East Elementary School

Town of Hingham ADA Transition Plan

October 2023

Institute for Human Centered Design

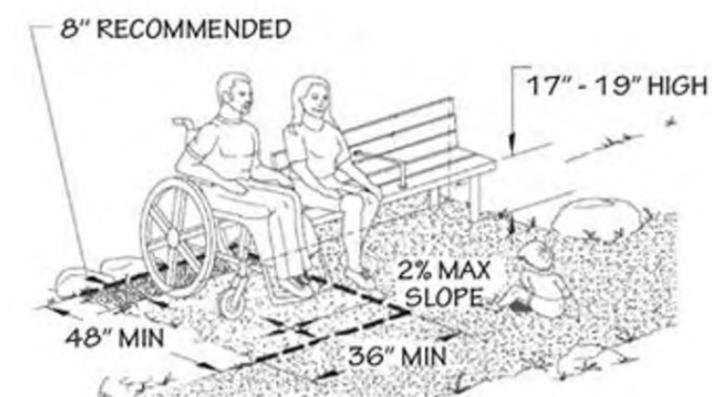
- Recommend rotating the accessible picnic table on the south side of the school so that it is easier to get around all sides. Recommend providing a 36" min. by 48" min. stable, firm and slip-resistant surface adjacent to at least one bench by the main entrance in a manner that is substantially similar to what is shown in Figure 1.

Figure 1 shows a stable, firm and slip-resistant surface adjacent to a bench positioned to allow a person in a wheeled mobility device and a person sitting on the bench to have their shoulders aligned:

Additional Accessibility Issues

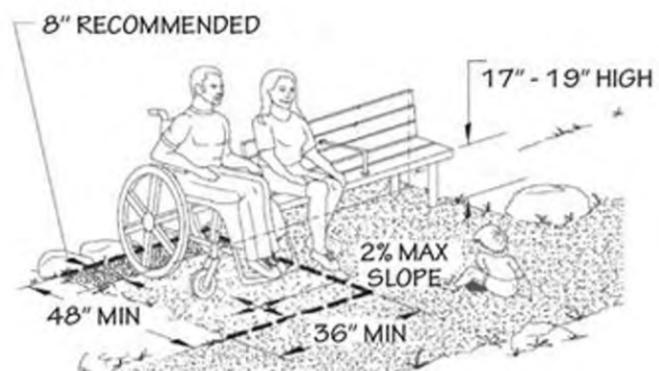
- Service counters higher than maximum allowed in the guidance office and the media center.
- Coat hooks located higher than allowed in classrooms.
- Lack of clear floor space at the book drop off in the media center.

- Lack of compliant spigots in the courtyard near the garden bed and lack of an accessible route to the spigot.
- Lack of a handwashing sink with compliant hardware by field M and lack of an accessible route to the handwashing sink.

Additional Accessibility Issues

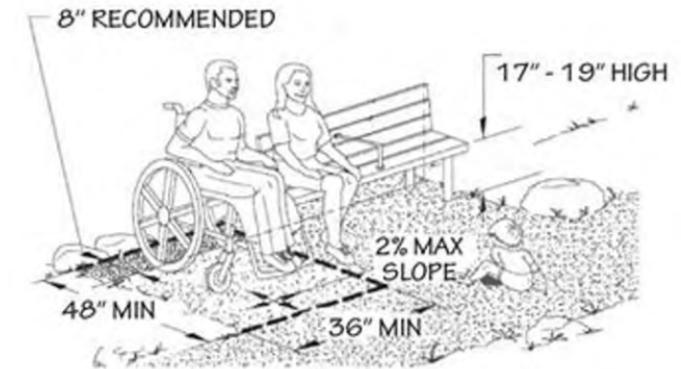
- Lack of an accessible route to at least one (1) bench by the tennis courts.
- Lack of an accessible portable toilet that is on an accessible route by the soccer field.
- Lack of five (5) percent of accessible lockers in the boys' and girls' locker rooms, locker room 1359 near room 125, and the boys' locker room changing area.
- Lack of an accessible bench in the girls' locker room changing room by the shower and in the boys' locker room.
- Clear floor space is not provided alongside at least one of each type of fitness equipment in the wellness center.

- A defibrillator in the corridor by the gym is located higher than allowed.
- There is a lack of a drinking fountain for standing users in the corridor by the gymnasium.
- The sink in the occupational therapy/physical therapy room and the sink in the technology application lab lacks clear floor space because of equipment located underneath. The sink in the technology application lab also lacks pipes that are insulated or otherwise configured to prevent against contact.

Additional Accessibility Issues

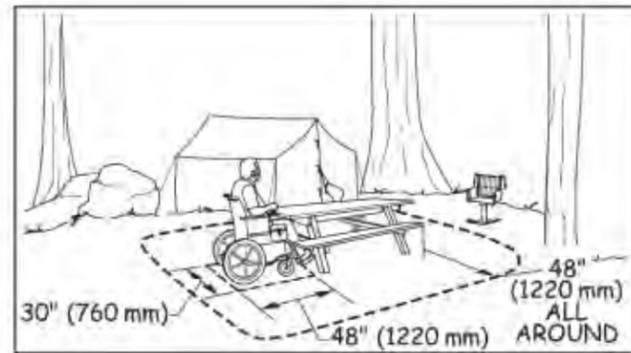
- The lift to the stage in the auditorium was not functional on the day of survey. Ensure that the controls are functional and can be independently operated.
- The interior ramp by the cafeteria and main entrance has an excessive running slope.
- Protruding objects are present in several locations.
- The lock to the door by toilet room T11 is not operable.
- A paper towel dispenser in the first grade classroom (room 27) has controls that require tight grasping, pinching, or twisting of the wrist.
- At the main entrance, the phone is located higher than allowed and access to the emergency control box is lacking clear floor space as it is blocked by a table.
- A piece of wood is located in the required toe clearance of the sink in Special Education Classroom 13.

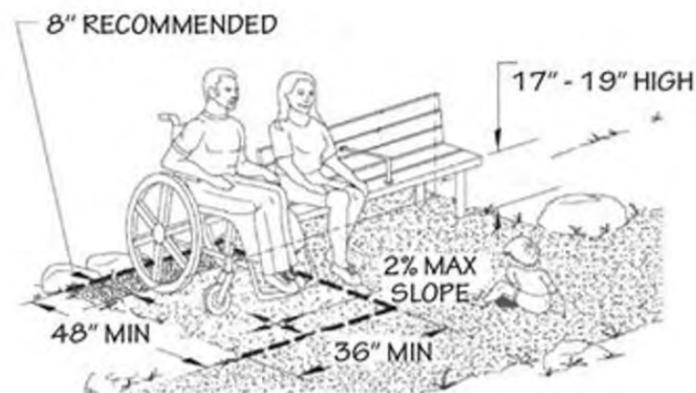
- Recommend providing visual contrasting color strips on the treads of the stair by the main entrance.
- Recommend providing an accessible route from the library exit to the nearest right-of-way.

- Recommend locating all classroom designation signs on the glass directly next to the door.
- Recommend providing an automatic door opener at the main entrance.

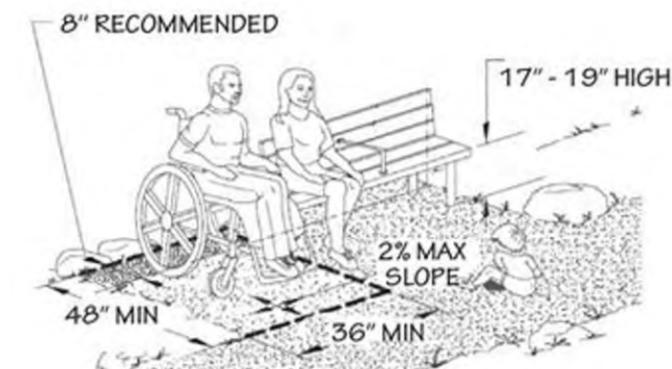
- A curb ramp by the main entrance has damage at the base and is not stable, firm and slip-resistant.
- Furniture and other items obstruct the required clear width in the library and reading room.
- The route from the cafetorium stage lift was blocked by equipment and cables on the day of survey.
- Protruding objects are present in several locations.
- Ensure that five (5) percent of lockers are accessible, with hardware that can be operable with one hand and not require tight grasping, pinching, or twisting of the wrist.
- The ramp in the library lacks handrails that extend horizontally above the landing for 12" min. beyond the top and bottom of the ramp run.
- Drinking fountains are not provided for seated users by the guidance office or for standing users by Egress Door 8.
